IN THE DRAWINGS

REMARKS

Mark Bellm et al. ROTARY CUTTING DEVICE AND METHOD FOR MAKING SAME Attorney Docket No. 7262-005/Application No. 10/682,314

Fig. 8 A
(PRIOR APT)

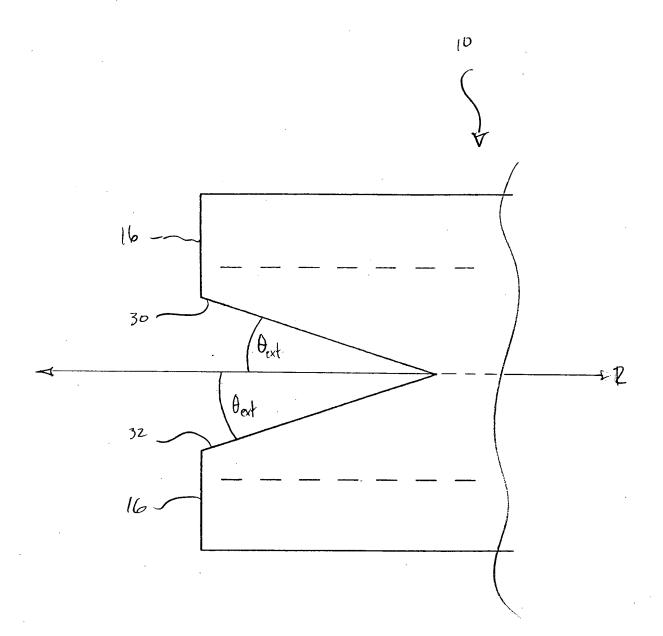
The attached replacement sheets of drawings include changes to Figs. 2A, 4, 6A, 6B, 7A, 7B, 8A, 8B, 9, 10, and 11. These sheets replace the original sheets of drawings. Annotated sheets showing changes are also attached.

The attached annotated drawings are marked in red to indicate revisions proposed by applicants to address the objection to the drawings. Also attached are replacement drawings. Applicant respectfully traverses the examiner's objection (2) to Fig. 4 on the basis that reference numeral "18" is not described in the specification. It was mentioned in the application as filed on page 3, line 12. Applicant has therefore retained reference numeral "18" in Fig. 4. The remaining objections to the drawings have been addressed by striking the references that are not mentioned in the text.
